## Lot 33 Hopkinson Road, Cardup - Structure Plan - Schedule of Modifications

## Modifications

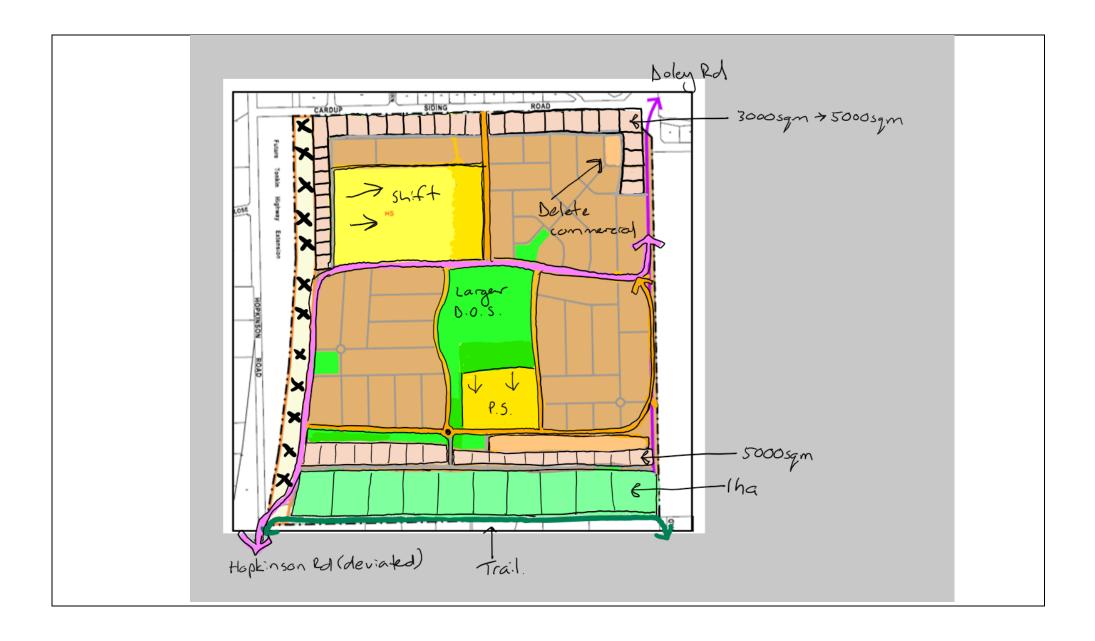
Should the WAPC be of a view to consider supporting the Structure Plan, it is recommended a number of redesign issues first be undertaken and addressed, including:

- The requirement to provide two, properly constructed points of access in order to address bushfire risk which take account of the loss of access associated with the future Tonkin Highway;

- Subdivision not taking place until Doley Road is connected through to the subject land from the northeast, and Hopkinson Road through to the subject land from the southwest;

- Removal of the commercial node, noting that the adopted Byford District Structure Plan focuses the future neighbourhood centre at the intersection of Orton Road and Doley Road, rather than further south;

- Adjustment to the current integrator road arrangement on the eastern side of the subject land, to be replaced by a more logical road link that connects between Hopkinson Road (deviation), future school precinct, district open space and Doley Road, with integrator and neighbourhood connector road arrangements;

- Improving the transition to rural residential properties to the south, and special residential properties to the north, through lowering densities and deepening lot depths to provide greater separation;

- Defining the future public open space network in clearer terms, especially those associated with the proposed district open space and smaller open spaces;

- Removing the designation of urban development along the Water Corporation utility corridor, and clearly determining how this corridor will be managed and what setbacks and interfaces are required to be provided;

- Addressing the appropriateness of placement of schools and residential development proximate to the future Tonkin Highway extension and whether noise impacts can be managed as a result;

- Lack of certainty as to how servicing of the site is to be undertaken noting the reliance on a future Doley Road extension which currently does not exist;

- Provision of an equestrian pathway running along the full length of the southern boundary of the site, to further assist with interface to the south.

- Redesign of the Structure Plan to reflect the below concept design:
